Responses to NRC Letter Dated July 17, 1998
Request for Additional Information on the Reclamation Plan for the White Mesa
Uranium Mill

Source Material License SUA-1358
Docket No. 40-8681

Re: White Mesa Uranium Mill
Response to NRC's Questions Dated July 17, 1998
Site Reclamation Plan

International Uranium (USA) Corporation White Meso Mill		
EXISTING & PROPOSED SETTLEMENT MONITORS CELL 2 & 3 FIGURE 1 - ATTACHMENT 4		
DESIGN: BAH	DRAWN:	SHEET 1 of 1
CHKD BY:	DATE: 8/17/88	
APP:	SCALE: 1" = 200'

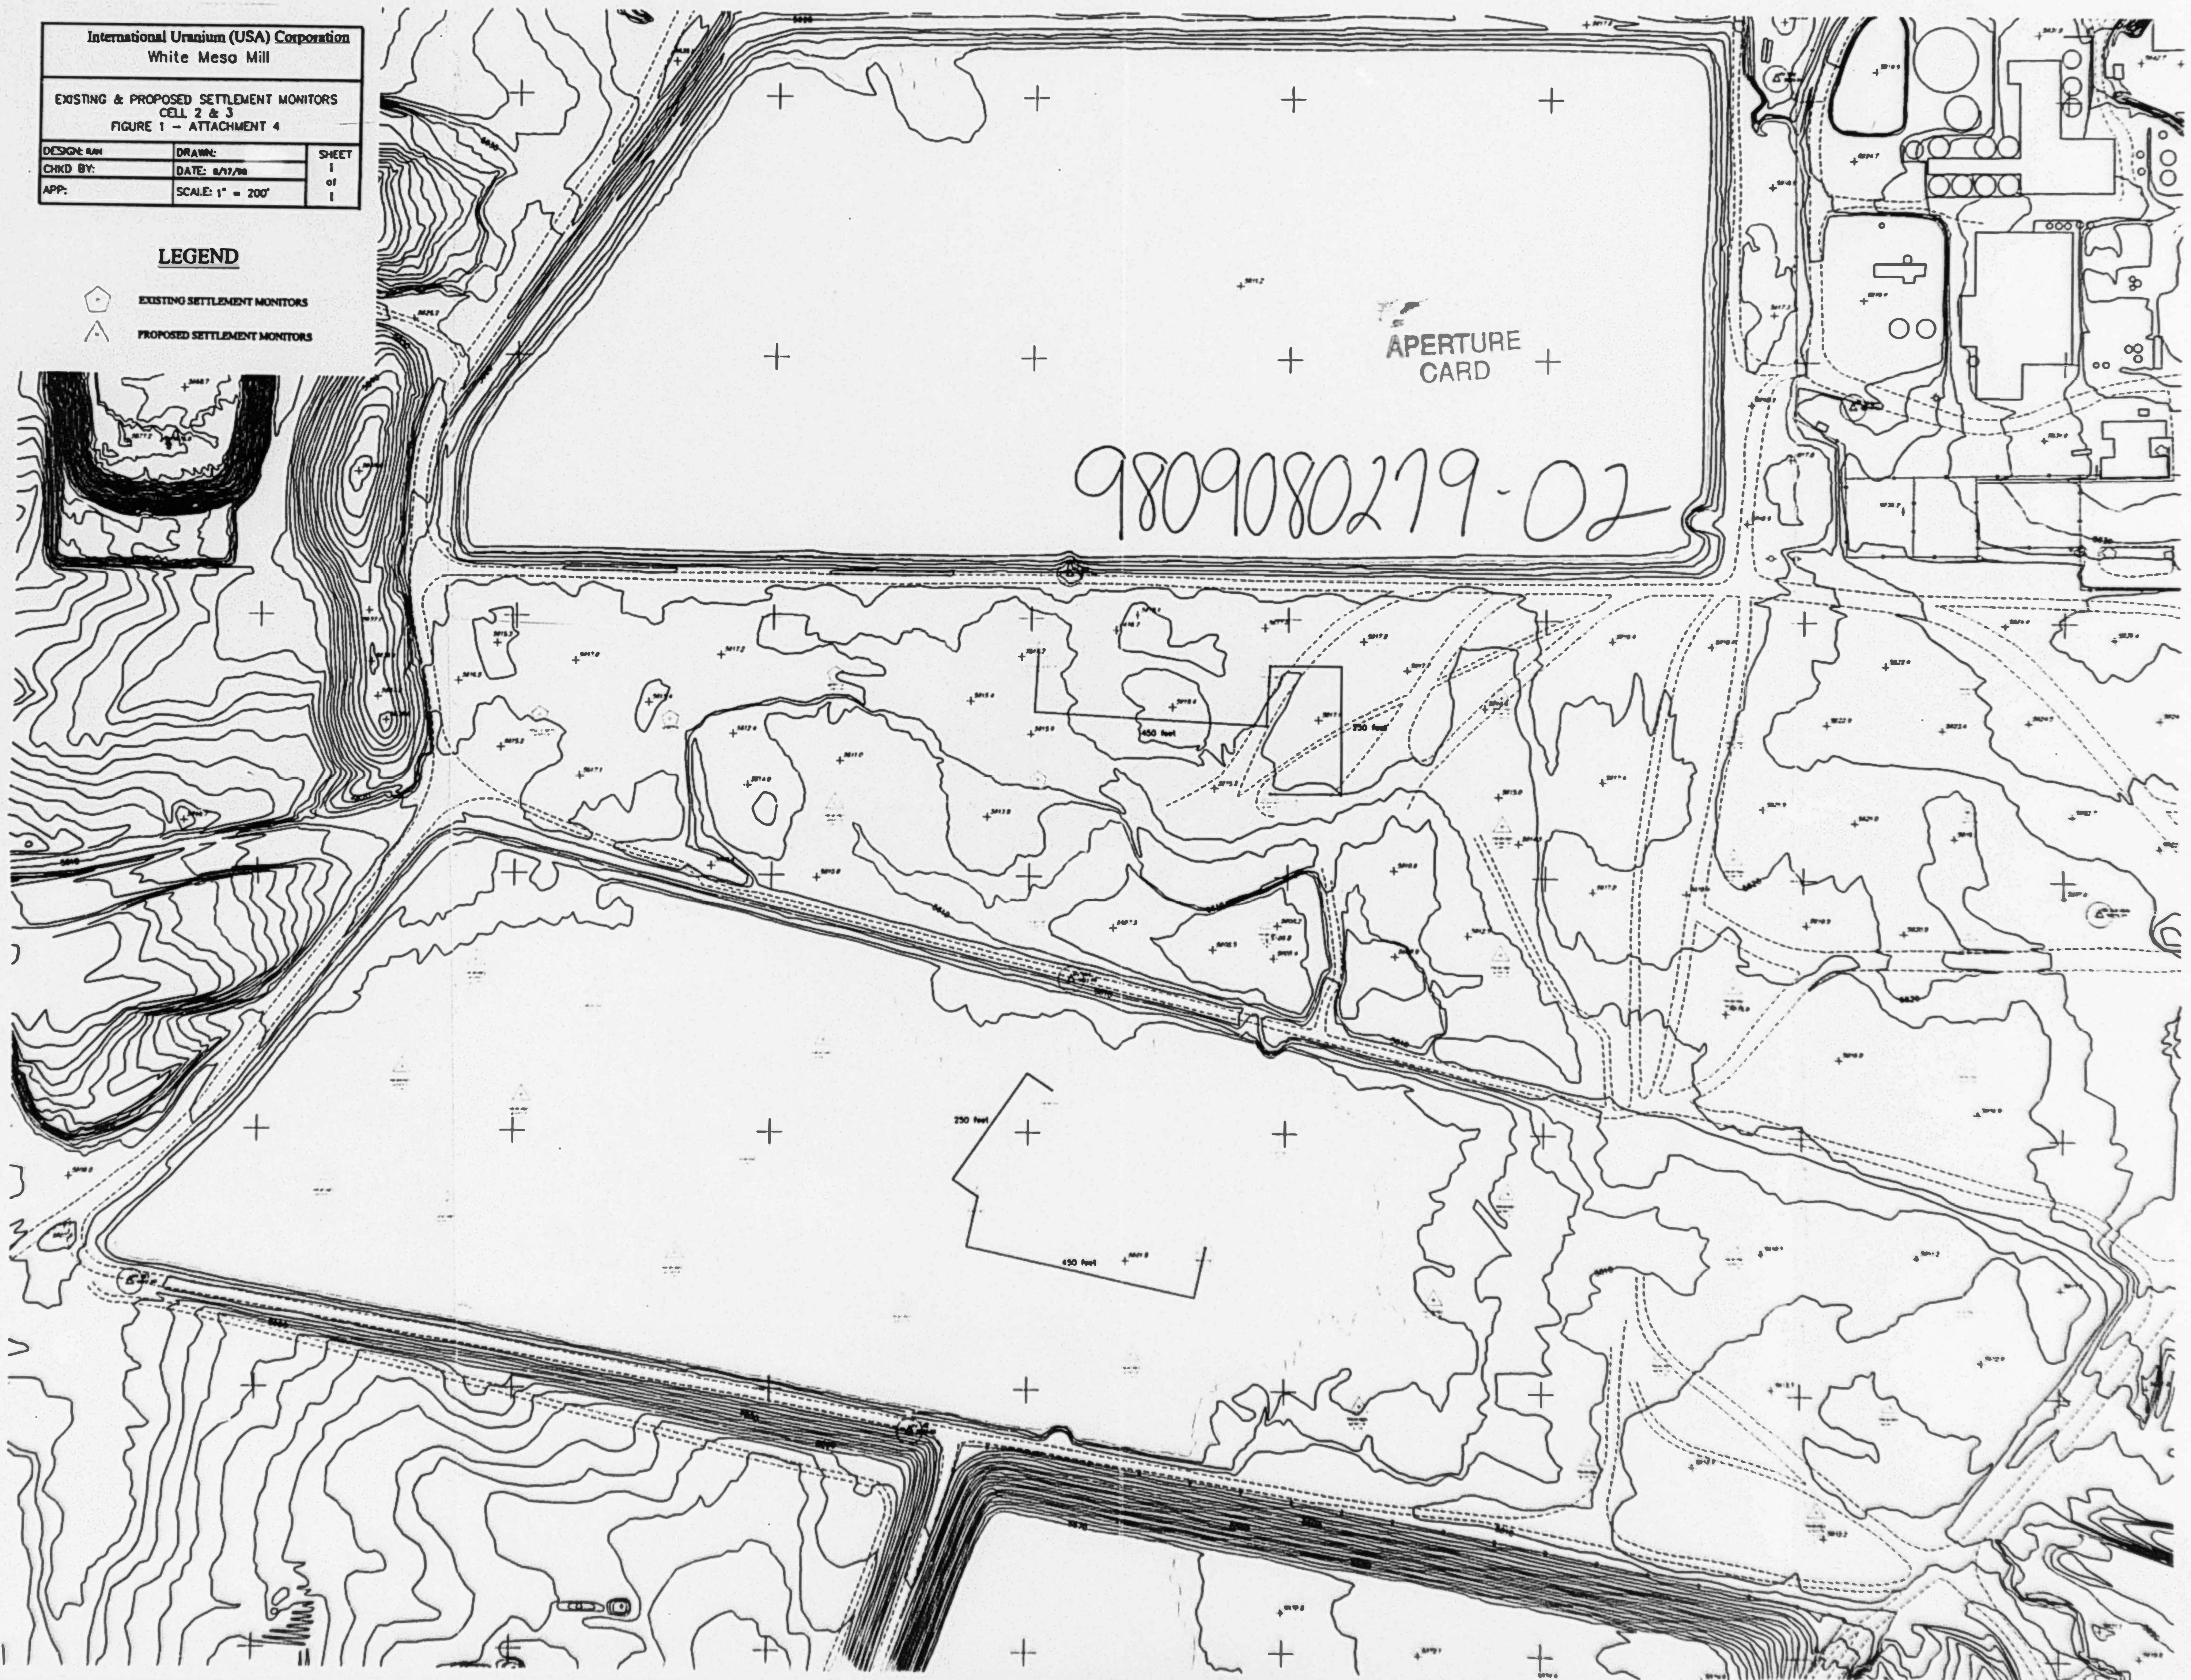
A plan for settlement measurement that is satisfactory for producing representative settlement data throughout the disposal cells is required. Settlement measurement stations should be of sufficient coverage and should be strategically placed to yield adequate information for determination of differential and residual settlements. Monitoring monuments should be designed to be durable.

Figure 1 of Attachment 4 shows the location of existing and proposed settlement monitoring locations on existing Cells 2 and 3.
